LOCKHEED AIRCRAFT CORP.	ENGINEERING STUDY ☐ CHANGE PROPOSAL ☒	LAC - 32
DATE 6-4-59	AFFECTS: WSPO ☒	PROJECT ☒

TITLE OF PROPOSAL: SUN SHADE ASSEMBLY - REPLACEMENT

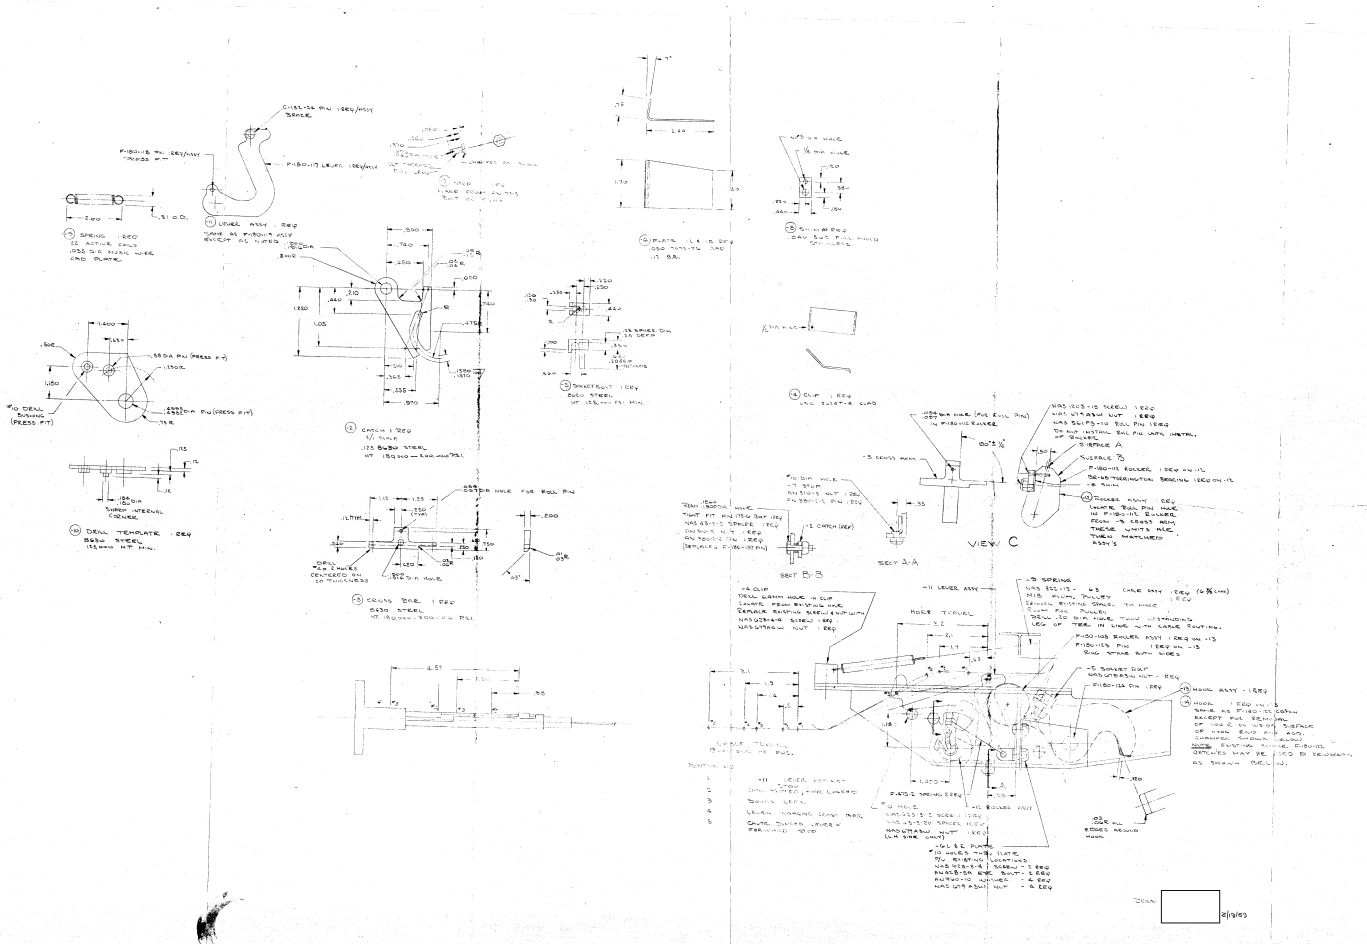
1. REPLACE PRESENT SUN SHADE ASSEMBLY (F259) WITH REVISED SUN SHADE PER 75Q 11 (ENCLOSED)

TO INCORPORATE PROVISIONS TO MAKE SUN SHADE REMOVEABLE FOR STOWAGE, ELIMINATE EXCESS FLEXIBILITY, PREVENT SUN SHADE FROM SLIPPING OUT OF POSITION, AND SHORTENED SHADE TO PROVIDE MORE HEAD CLEARANCE. NEW SHADE WILL PROVIDE CONSIDERABLY LONGER SERVICE LIFE.
REF.: UR 57-970; UR 58-491
